Illinois Department of Transportation

SUBJECT: MidAmerica St. Louis Airport
Mascoutah, Illinois
St. Clair County
Illinois Project Number: BLV-5101
AIP Project Number: 3-17-0146-TBD
Contract No. SC071
Item No. 02A, April 26, 2024 Letting
Addendum A

NOTICE TO PROSPECTIVE BIDDERS

ADDENDUM A PLAN SHEET REVISIONS

CONSTRUCTION
ACTIVITY PLAN -
PHASE 1

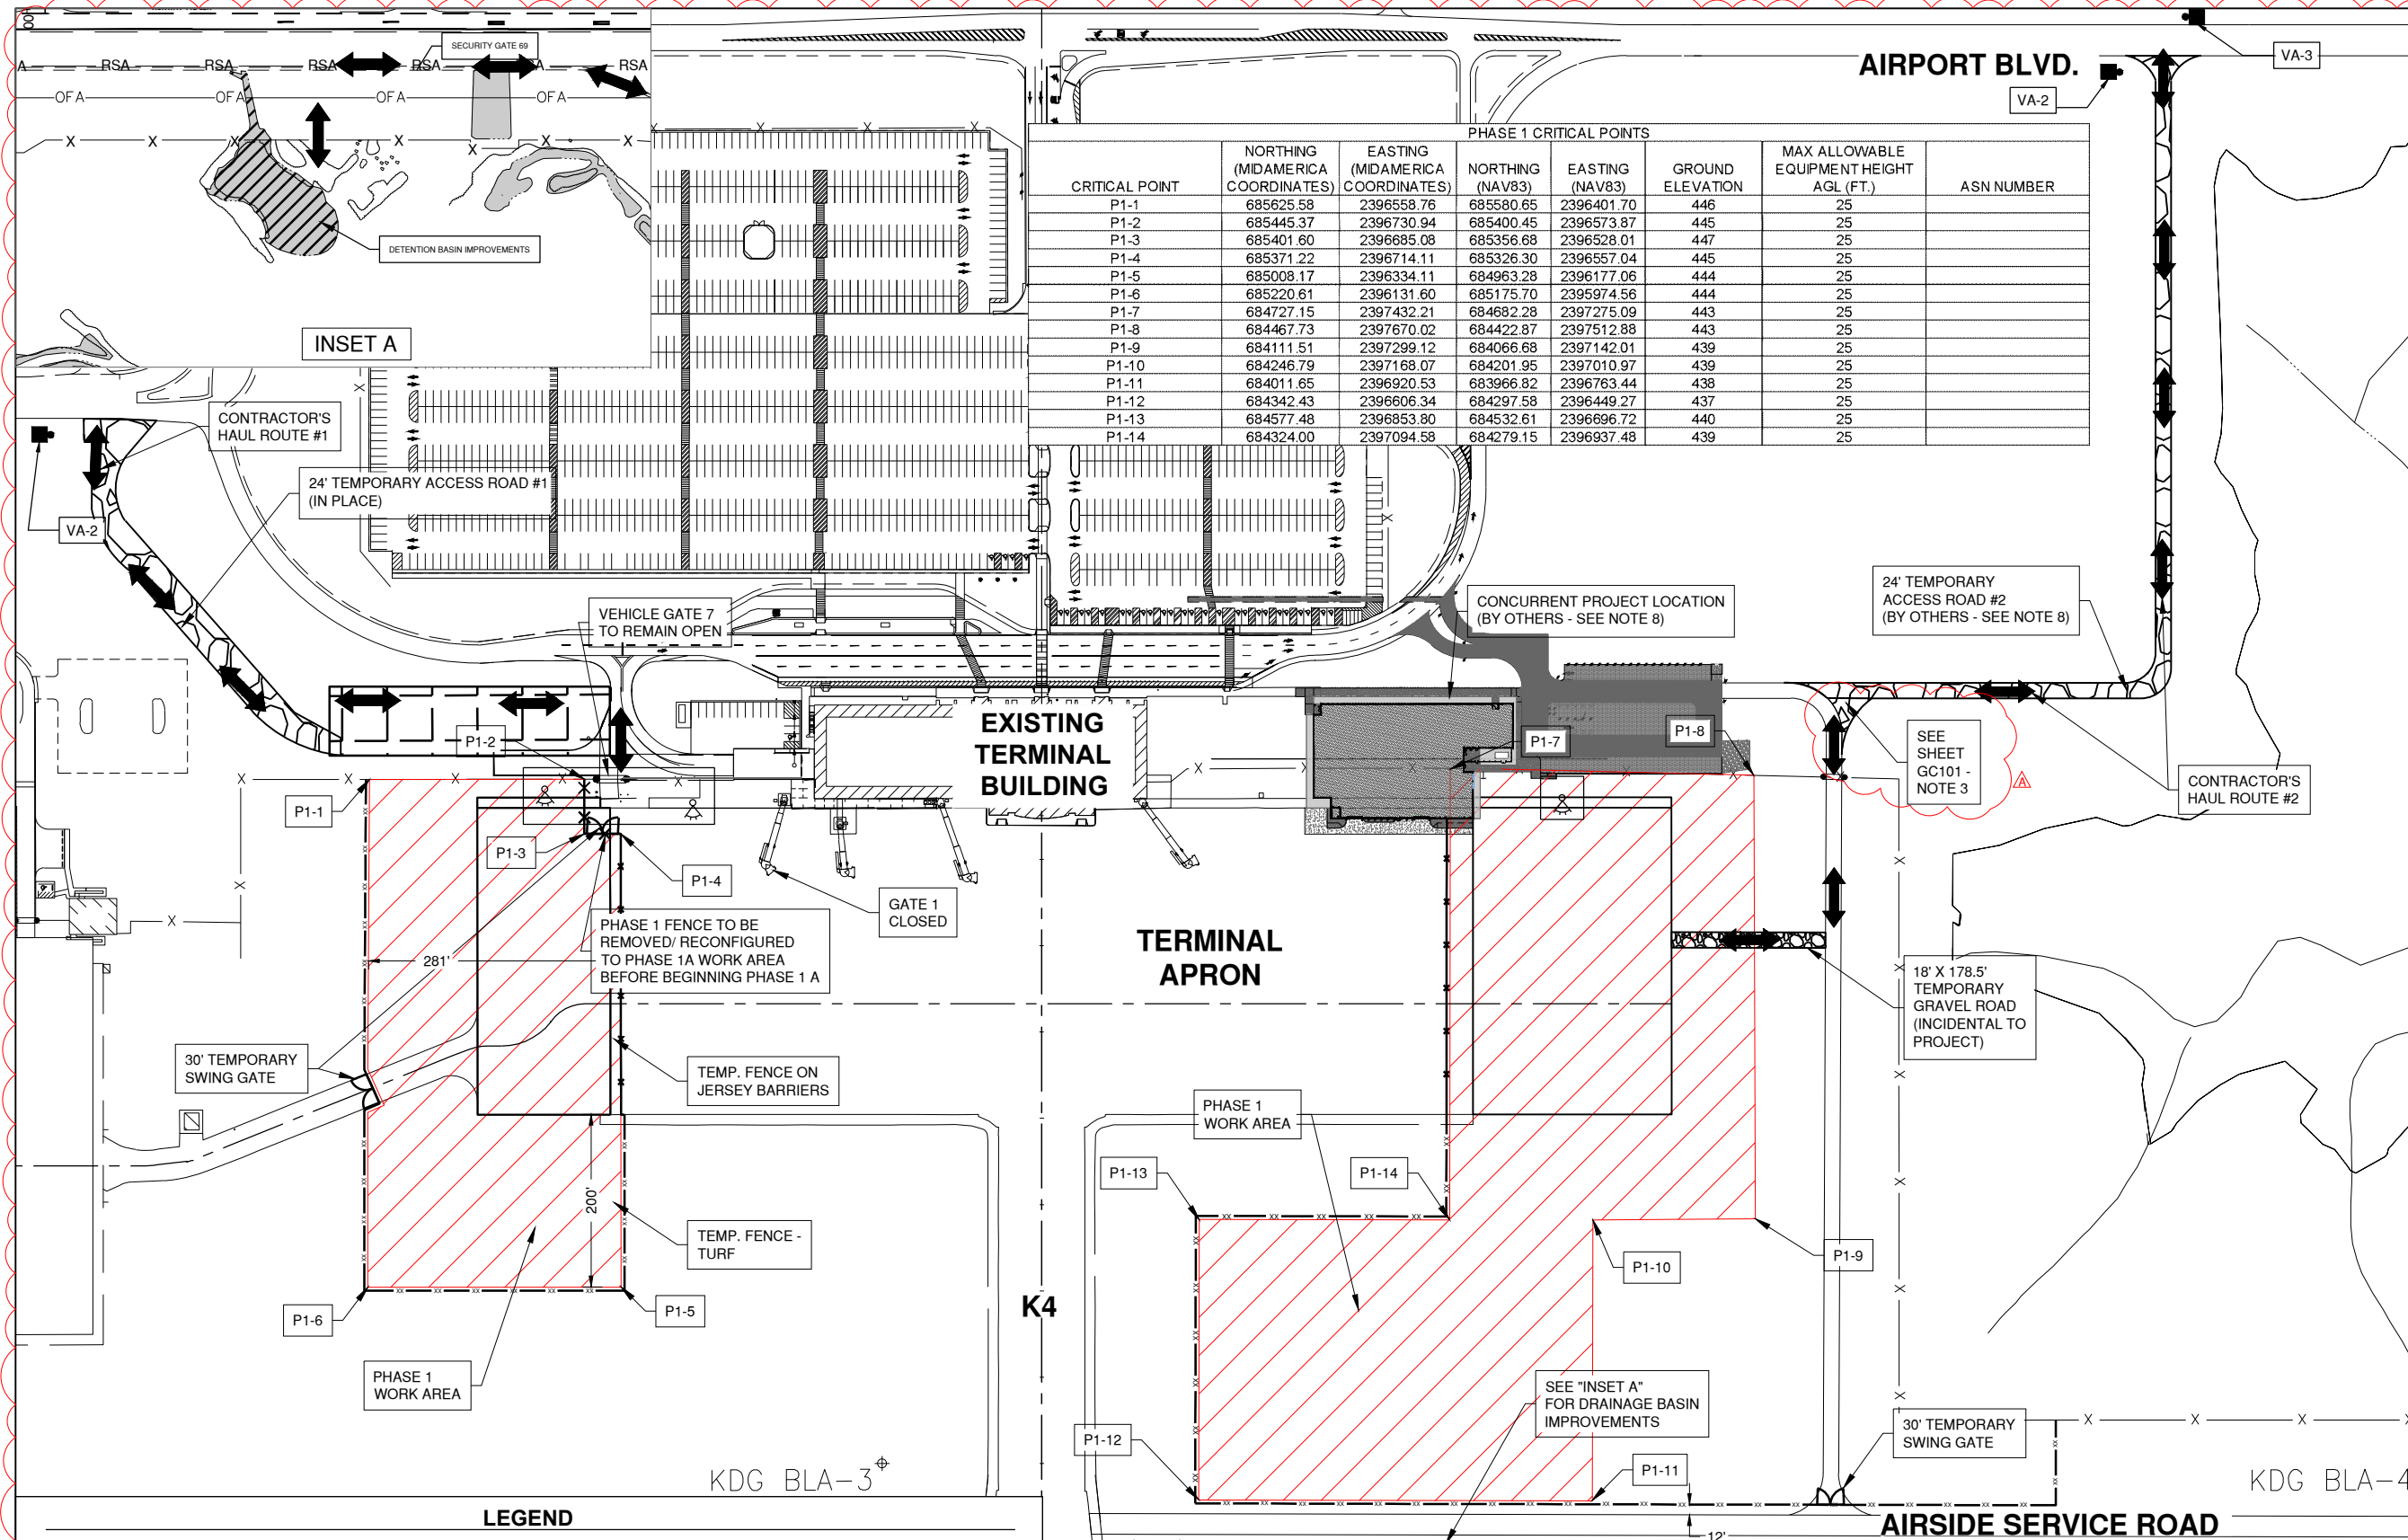
- Sheet GC102
 - Updated to add note for incidental haul route radius, temporary access gate, soil disposal area and soil disposal access.
- Sheet GC103
 - Updated to edit/clarify call-offs and dimensions for phasing area.

TEMPORARY FENCING PLAN

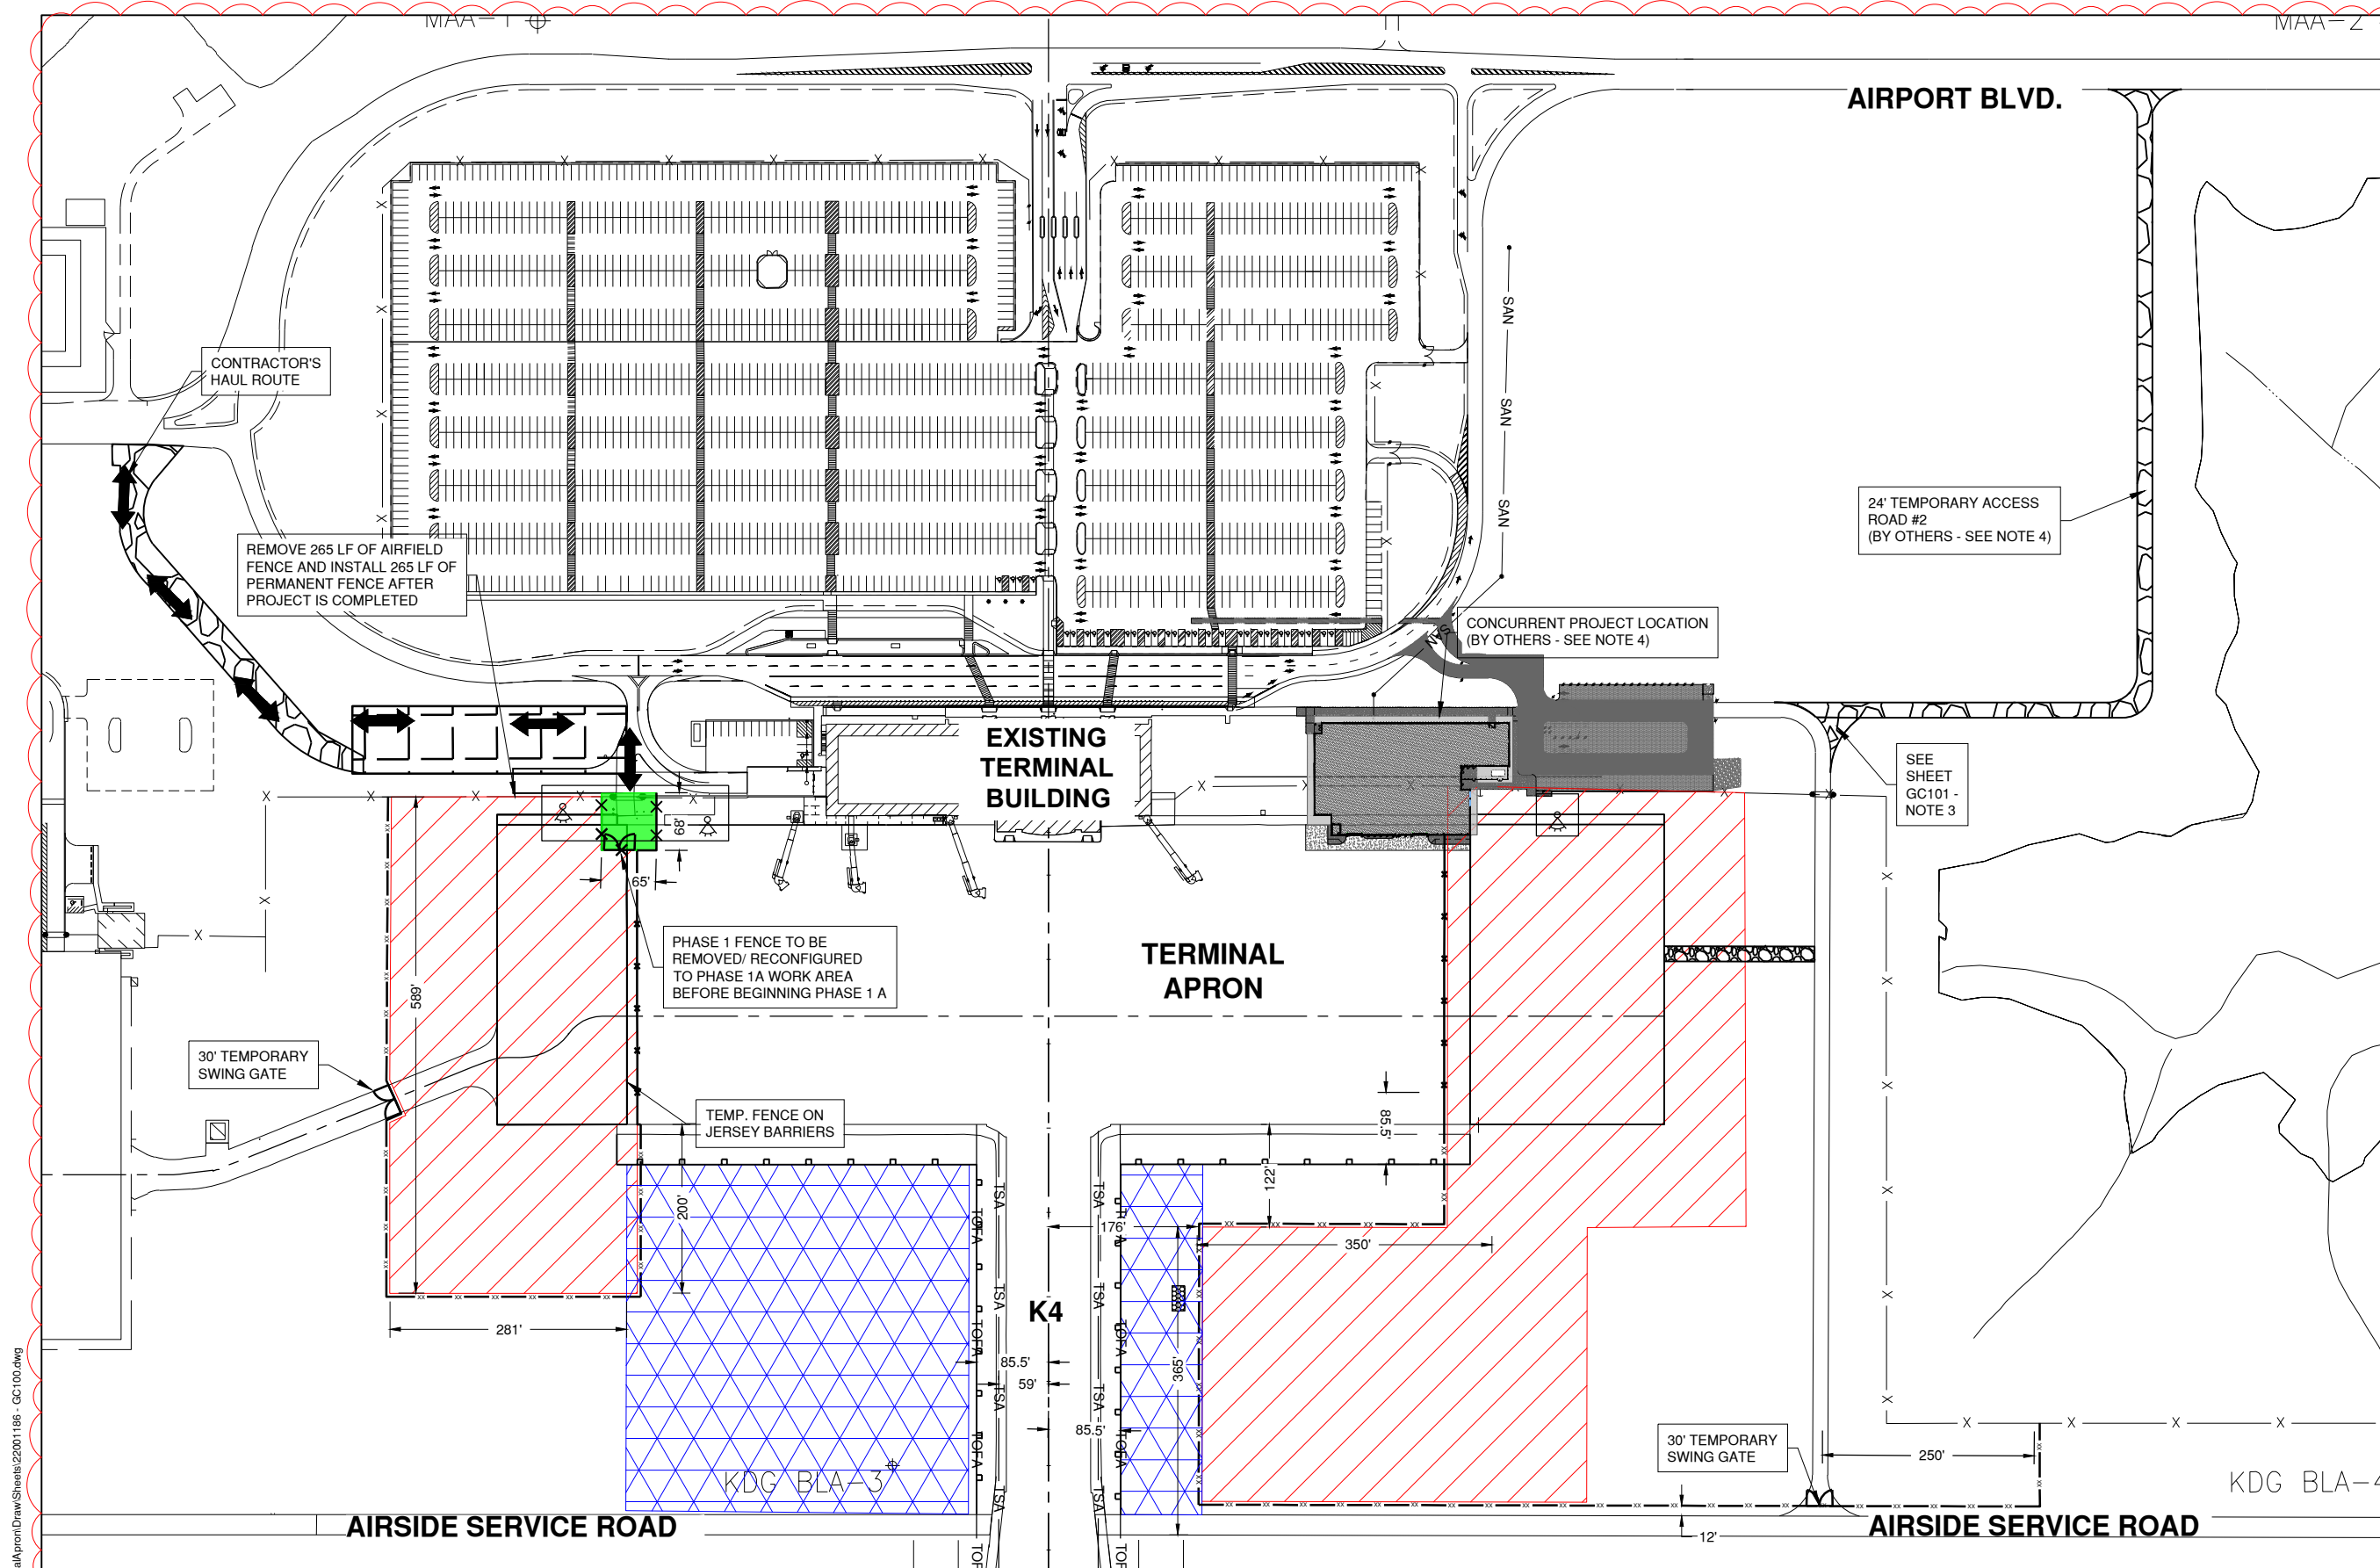
- Sheet GC104
 - Updated to delete unnecessary linework and show temporary fencing from Phase 1
- Sheet GC105
 - Updated to delete unnecessary linework
- Sheet LG101
